Reference: H09/0331/94

Description: Residential development, including means of access
and demolition of existing dwelling

Location : Battlefields Farm Battlefields Lane
Holbeach Spalding Lincs

RE: LAND AT BATTLEFIELDS LANE HOLBEACH - KINGSWOOD INVESTMENTS
(REF. PLANNING PERMISSION H09/0331/94)

SITE PLAN

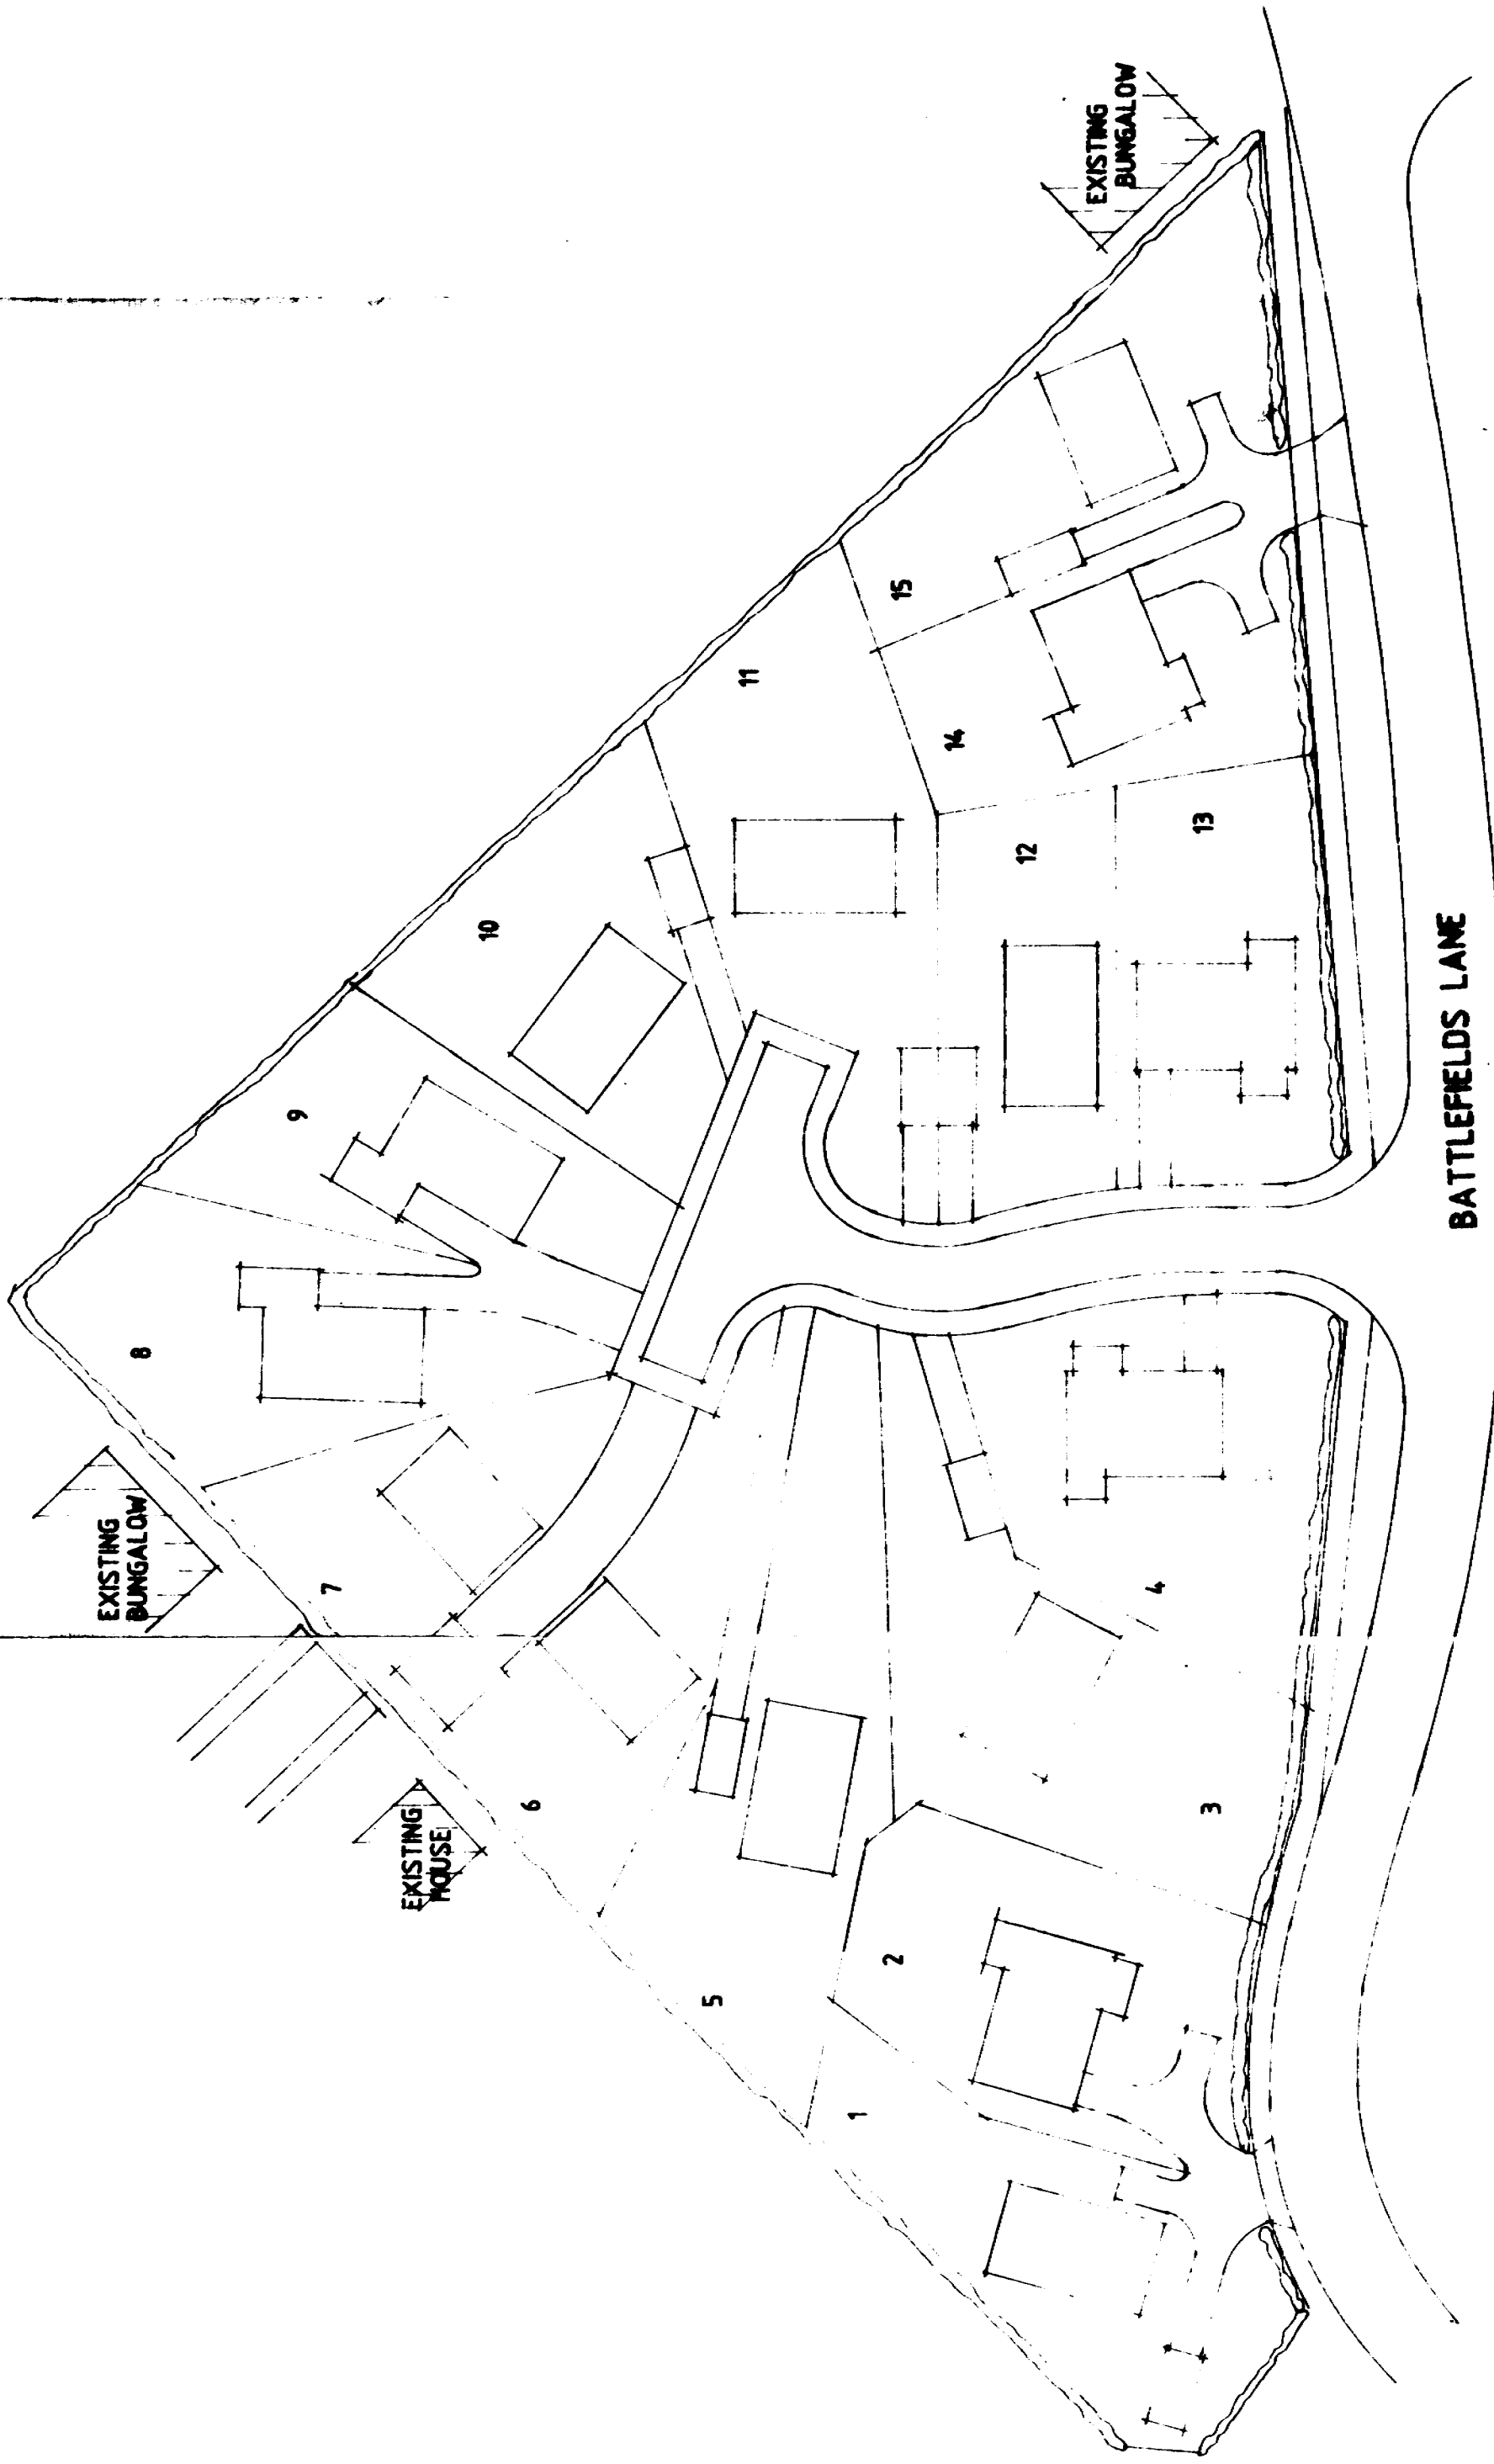
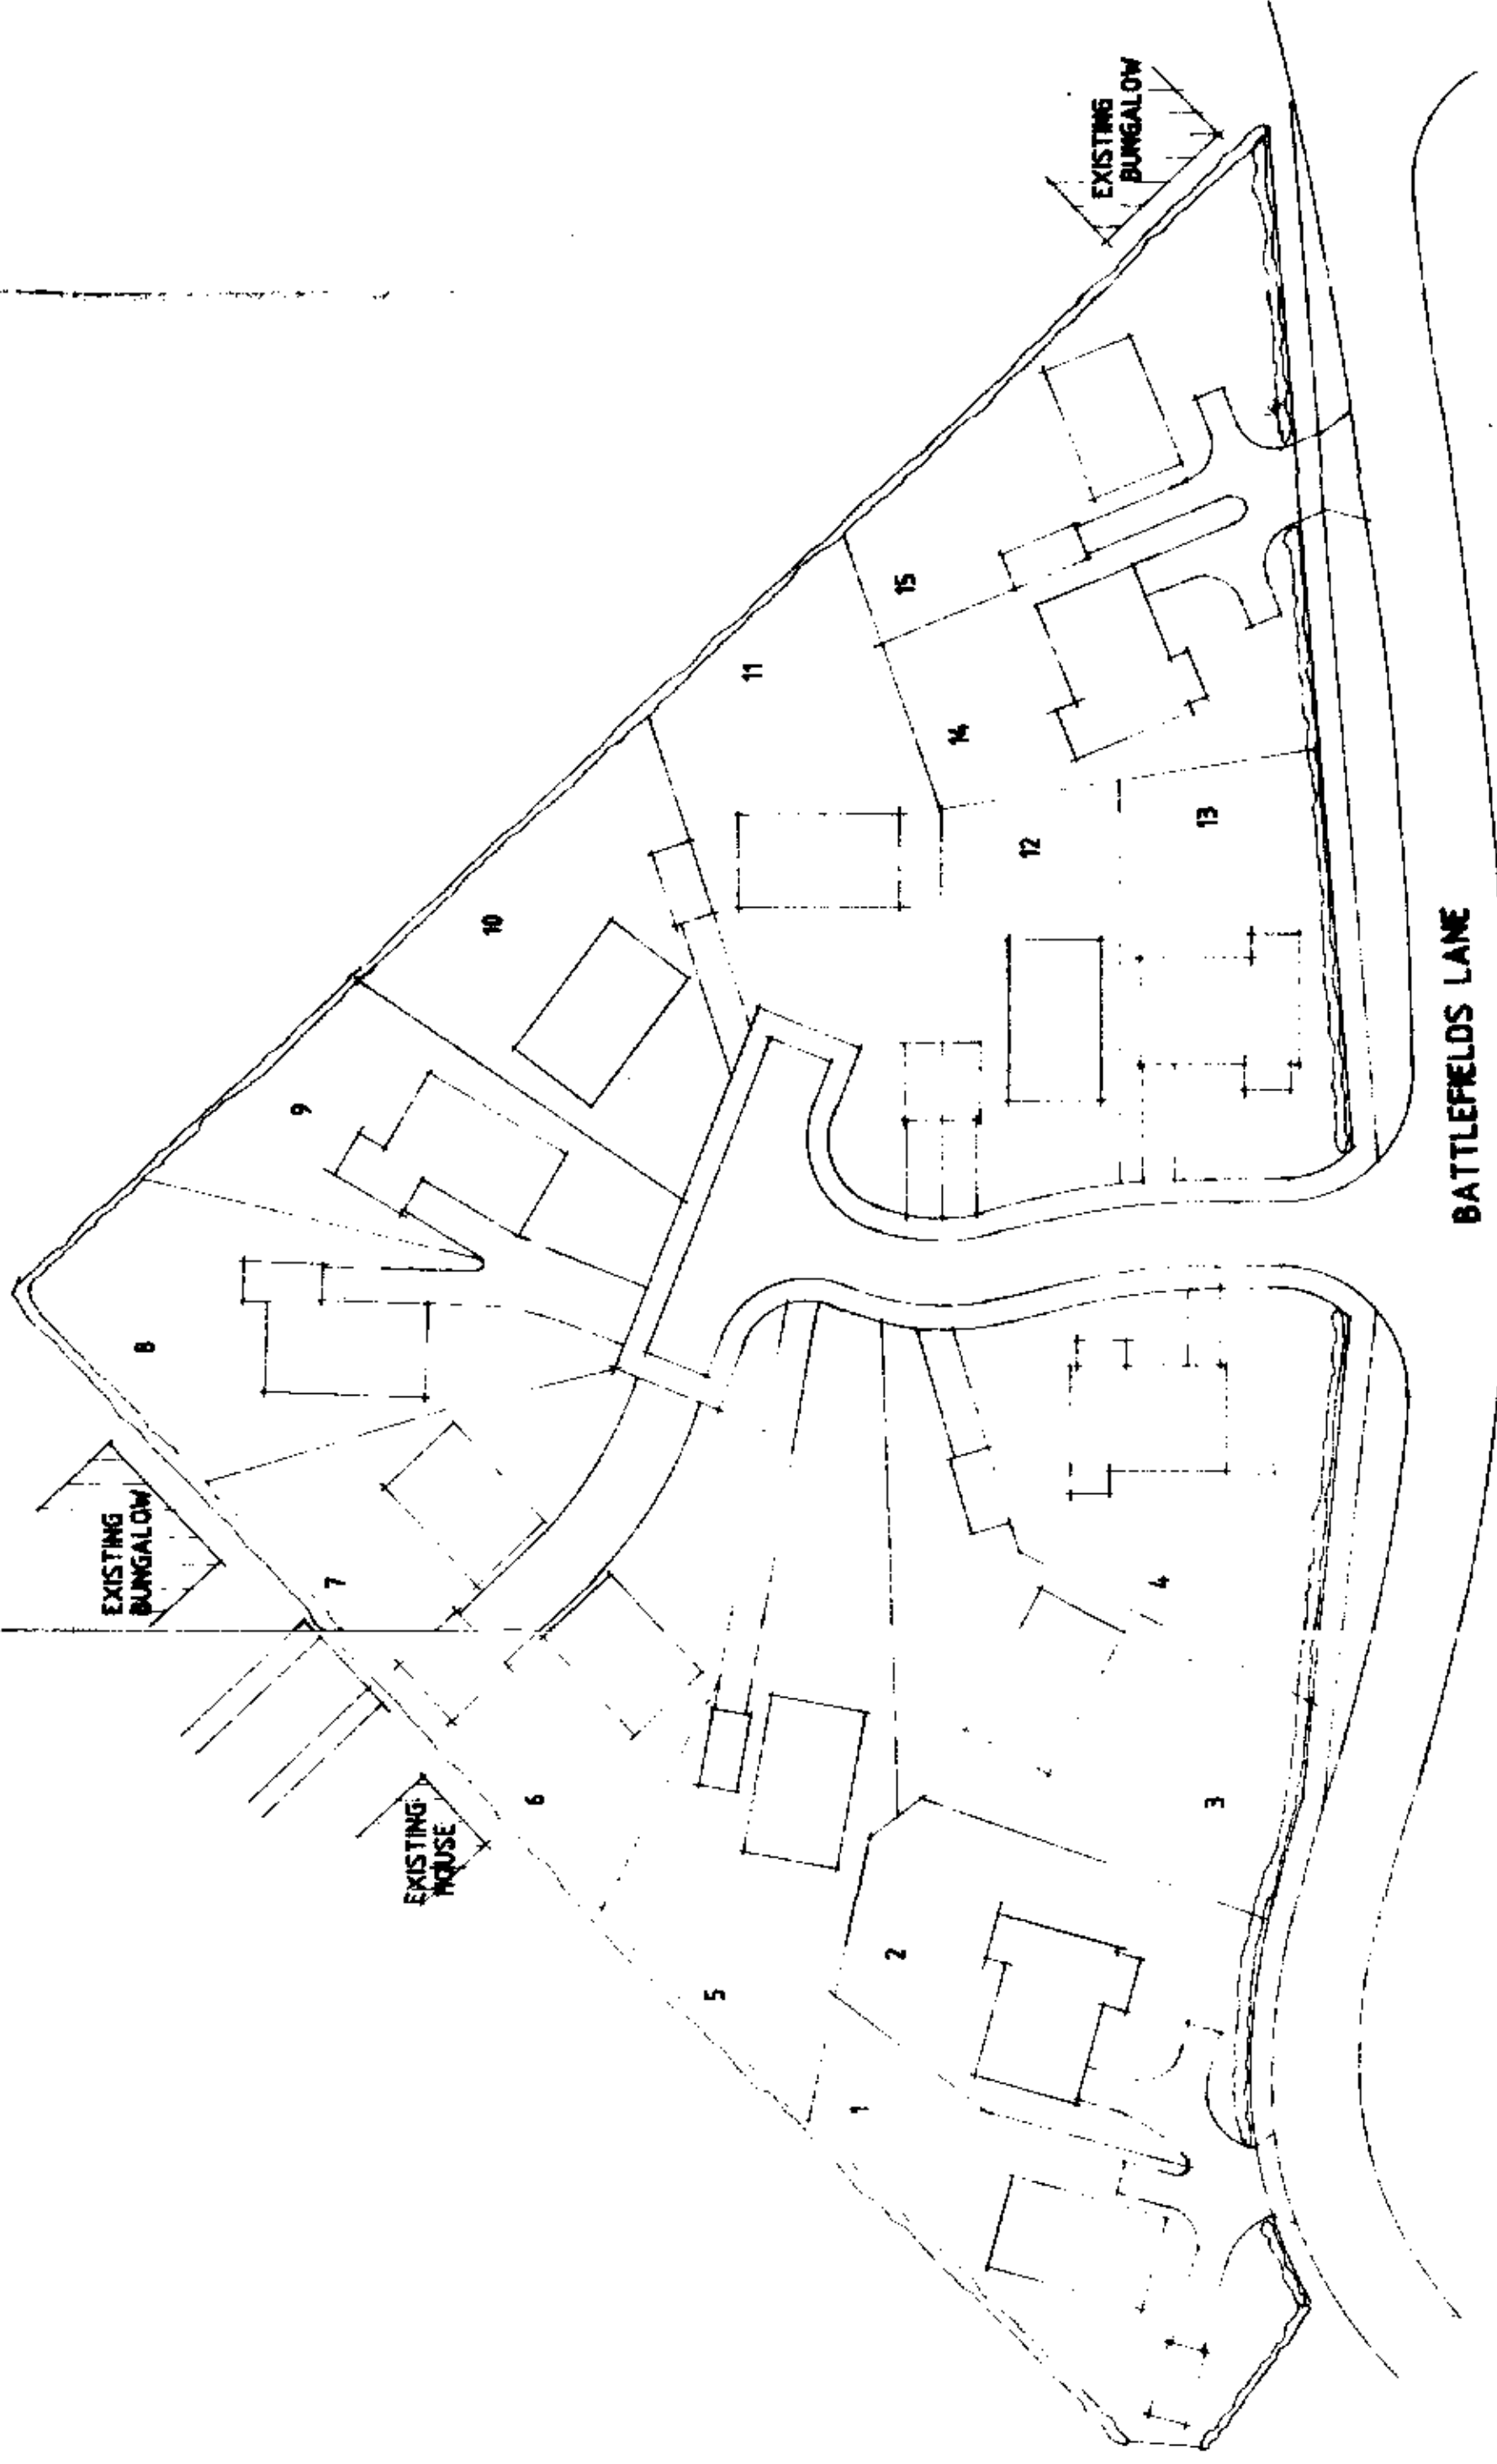
Having looked at your sketch drawing
KOH 150/3, I consider the layout now
proposed is a ~~more~~ substantial
improvement on that originally
envisaged. It provides a more cohesive
arrangement of buildings around the
central spur road.

The Director of Highways and Planning
has commented that in respect of
plots 2 and 14 the garage should
be sited a further metre back into
their respective plots to allow for
adequate parking and turning.

Having looked at your sketch drawing KQH150/3, I consider the layout now proposed is a substantial improvement on that originally envisaged. It provides a more cohesive arrangement of buildings around the central spur road.

The Director of Highways and Planning has commented that in respect of plots 2 and 14 the garage should be sited a further metre back into their respective plots to allow for adequate parking and turning.

Further to my letter to you dated 6th March 1996 and your subsequent response dated 1st April 1996, I enclose a revised Site Layout drawing no. KQH150/3 incorporating amendments to meet comments in your letter. In addition to this I enclose copies of the additional design types from those already supplied to you, namely Berkshire NG and Berkshire Modified.
